# **Response to Public Comments on Draft Regulatory Guide (DG)-1372** **“Design Limits, Loading Combinations, Materials, Construction and Testing of Concrete Containments”** **Proposed Revision 4 of Regulatory Guide (RG) 1.136**

On July 8, 2020, the NRC published a notice in the *Federal Register* (85 FR 41071) that Draft Regulatory Guide, DG-1372, a proposed revision of RG 1.136 was available for public comment. The Public Comment period ended on September 8, 2020. The NRC received the comments listed below. The NRC has combined the quoted comments and NRC staff responses in the following table.

Fig. 1—Stress-strain diagrams showing methods of yield strength determination.

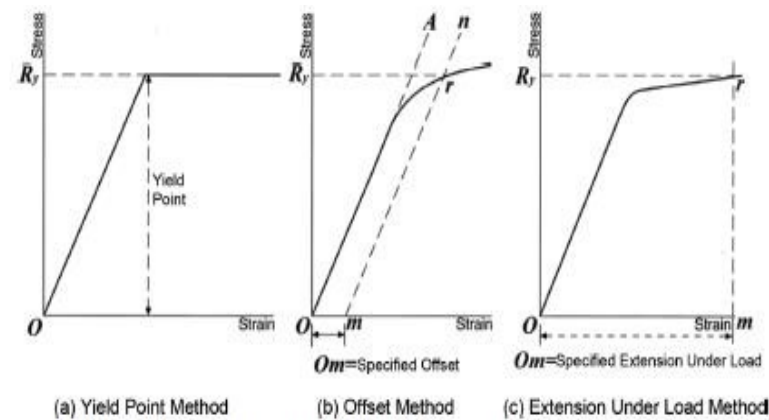
Based on testing of rebar in the industry, it is not uncommon for the measured actual yield and tensile strengths within a particular rebar heat and grade, or in each 60-foot length of rebar, to vary by as much as 5%. Determining the actual yield or tensile for qualification samples based on a single tensile test, or extracting from the CMTR in the case of production samples, will result in occasions where samples are falsely rejected or accepted simply because the determined yield strength is not truly representative of the actual length of rebar used in the mechanically spliced or headed sample. In addition, the methodology for determining the yield strength needs to be more clearly defined for steels with a “roundhouse” characteristic when a sharp yield plateau is not present.

Variation of methodology of extension under load EUL vs offset vs drop of beam methods can produce significantly different yield values. The methodology for yield determination for the steel characteristic needs strictly defined in DG-1372 to utilize the lower of the methods, because of the variation cited previously.

regulatory position 11. However, it should be noted that code paragraph CC-4333.2.3(a) requires that the average tensile strength of the splices and mechanically headed deformed bars shall not be less than 90% of the actual tensile strength of the reinforcing bar being tested; this requires determination of actual tensile strength but as alluded in the comment, the Code does not state how the actual tensile strength is to be determined. This code requirement continues to remain as-is, but the staff has clarified in the RG that actual tensile strength should be determined in accordance with testing standards, definitions and methods specified in ASTM A370.
